City of Portland, Maine – Building or Use Permit Application 389 Congress Street, 04101, Tel: (207) 874-8703, FAX: 874-8716

Location of Construction: 548 Brighton Ave		Owner: Cook, Bernal		Phone: 772-4127		Permit No: 981358	
Owner Address: SAA		Lessee/Buyer's Name: Bernside Haircutters		Phone:		BusinessName:	
Contractor Name: Sign Design, Inc.		Address: P.O. Box 207 Westbrook, ME 04098		Phone: 856-2600		<div style="border: 2px solid black; padding: 5px; text-align: center;"> PERMIT ISSUED Permit Issued: DEC - 4 1998 CITY OF PORTLAND </div>	
Past Use: Salon		Proposed Use: Same		COST OF WORK: \$ _____ PERMIT FEE: \$ 35.00		INSPECTION: Use Group: _____ Type: _____ Signature: _____ Signature: _____	
Proposed Project Description: Install pylon sign		PEDESTRIAN ACTIVITIES DISTRICT (P.A.D.) Action: Approved <input type="checkbox"/> Approved with Conditions: <input type="checkbox"/> Denied <input type="checkbox"/>		Signature: _____ Date: _____		Zoning Approval: Special Zone or Reviews: <input type="checkbox"/> Shoreland <input type="checkbox"/> Wetland <input type="checkbox"/> Flood Zone <input type="checkbox"/> Subdivision <input type="checkbox"/> Site Plan maj <input type="checkbox"/> m

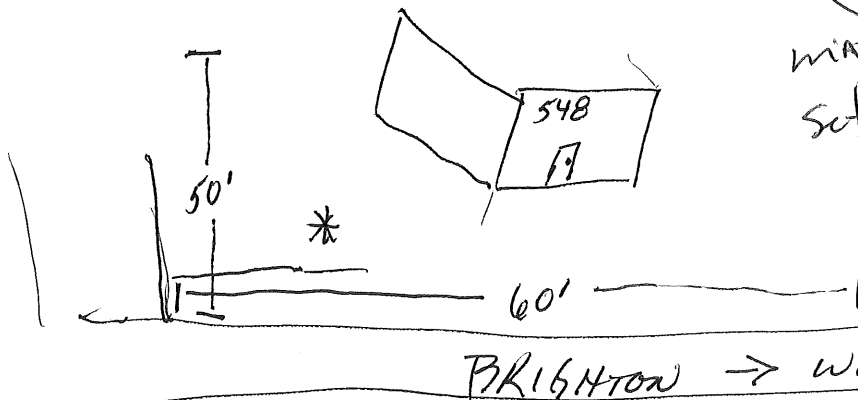
*(B1 Zone)
Area 32 sq Allow
max height 16'
setback - corner lot
provision*

*Show
50 ft
16 ft high
? with CO
REVISED
PLANS
dated 12/1/98
31,3 ft*

32#
4' X 8' ELECTRIC
SIGN CABINET

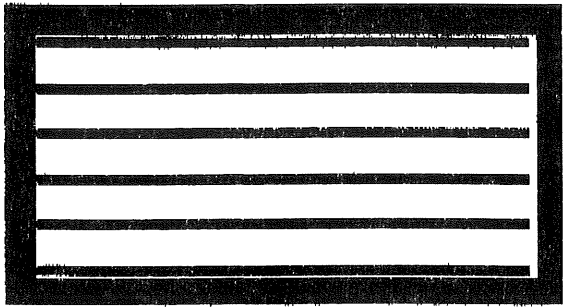
See
revised plan

OK
32^φ MAX Allowed

3' X 6' ELECTRIC SIGN CABINET = 18^φ

32" X 5' ELECTRIC SIGN CABINET = 13.3

31.3^φ
